OCPP 2.1 Edition 1
Errata 2025-09

This document contains errata on the OCPP 2.1 documentation. These errata have to be read as an addition to the release of OCPP 2.1 Edition 1.

Sequence Diagram: Cancel Reservation

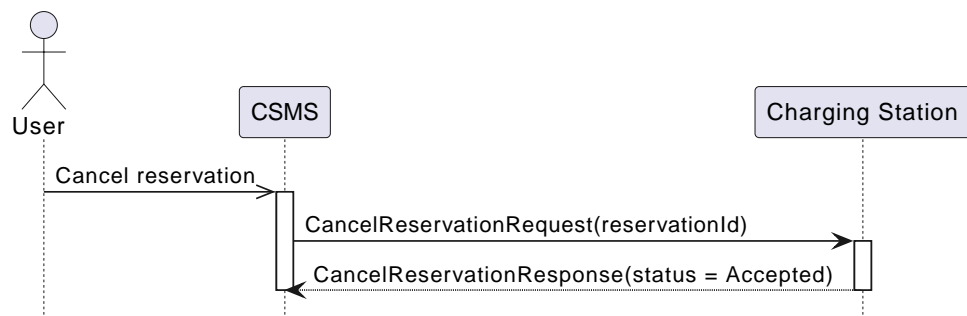
Added missing requirements explicitly specifying behaviour of Charging Station when a reservation is cancelled.

Removed details from sequence diagram

ID	Precondition	Requirement definition
H02.FR.03	H02.FR.02 AND If a specific EVSE was reserved for this reservation	The Charging Station SHALL allow charging again on this EVSE.
H02.FR.04	H02.FR.03	The Charging Station SHALL send a StatusNotificationRequest with status <i>Available</i> or a NotifyEventRequest with <i>AvailabilityState</i> set to <i>Available</i> to the CSMS for each connector, notifying the CSMS that all the connectors of this EVSE are available again for any EV Driver.
H02.FR.05	H02.FR.02 AND If no specific EVSE was reserved for this reservation	The Charging Station SHALL allow charging on all EVSE which were not reserved explicitly.
H02.FR.06	H01.FR.05 AND before cancelling the reservation the amount of EVSEs reserved was equal to the amount of reservations	The Charging Station SHALL send for all connectors of all EVSEs which were not reserved explicitly: - a NotifyEventRequest with <i>component</i> = "Connector", <i>variable</i> = "AvailabilityState", <i>trigger</i> = "Delta", <i>actualValue</i> = "Available", OR - a StatusNotificationRequest with <i>connectorStatus</i> = Available.
